Docket Item # 1
BAR CASE # 2011-00150

BAR Meeting
July 6, 2011

ISSUE: Alterations (storefront windows and benches)

LOCATION: 123 North Pitt Street (tenant space)
411 King Street (Tavern Square)

Figure 4. Proposed elevation – Pitt Street.

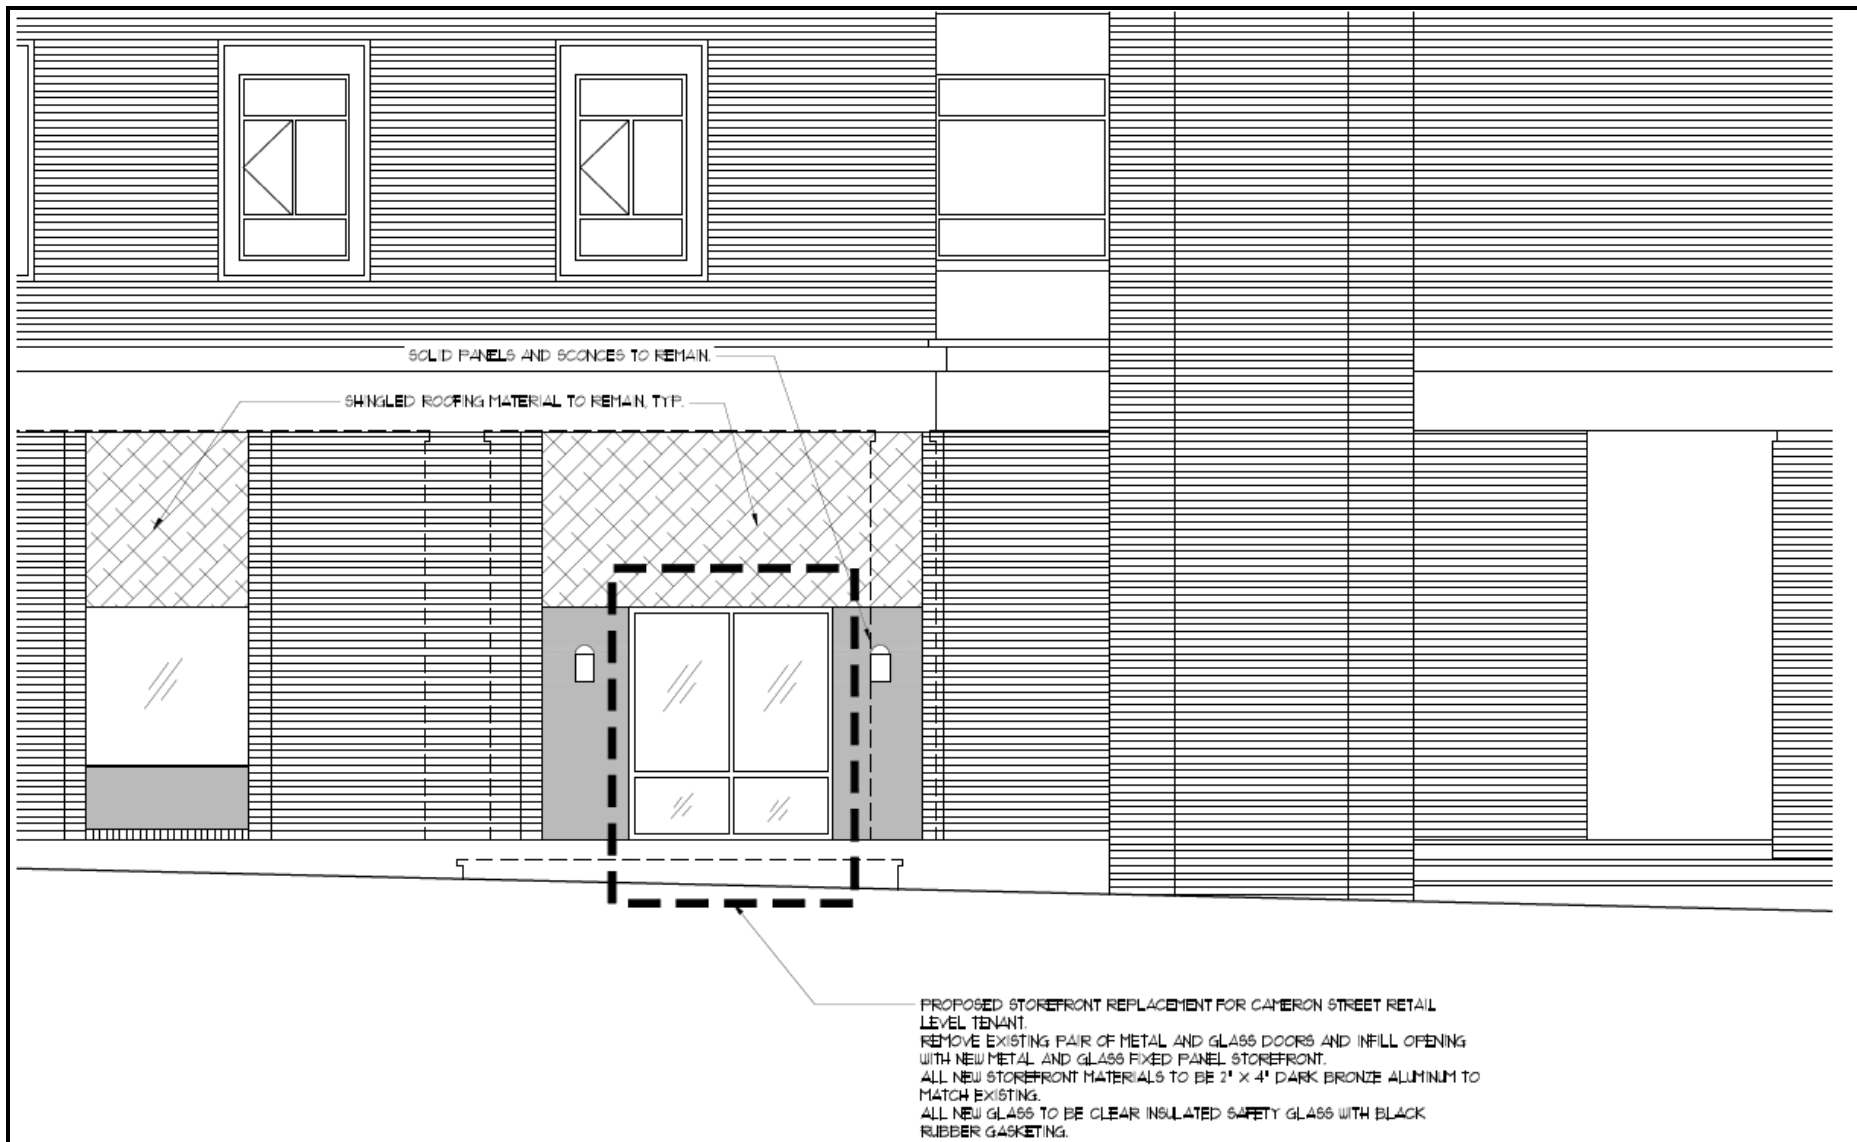
The applicant is requesting approval of a Certificate of Appropriateness for alterations to three storefront entrances in the Tavern Square development at 411 King Street. The proposed alterations are limited to the tenant space at 123 North Pitt Street. The existing doors – two on North Pitt Street and one facing Cameron Street – will be replaced with fixed storefront windows that will match the existing dark bronze aluminum storefront system installed throughout most of the building. The applicant, unfortunately, intends to retain the shingled panels above the doors, so this work is not before the Board.

As this building is not considered historic, at the present time, there is no concern for the loss of historic fabric. The proposed alterations will change the configuration of the openings, but will not affect the defining features of these spaces. The tenant space on the corner of Cameron and North Pitt streets has been used for office uses for some time and the proposed windows are more appropriate for the tenant's interior space layout. Should a retail tenant lease the space in the future, new doors could be easily reinstalled.
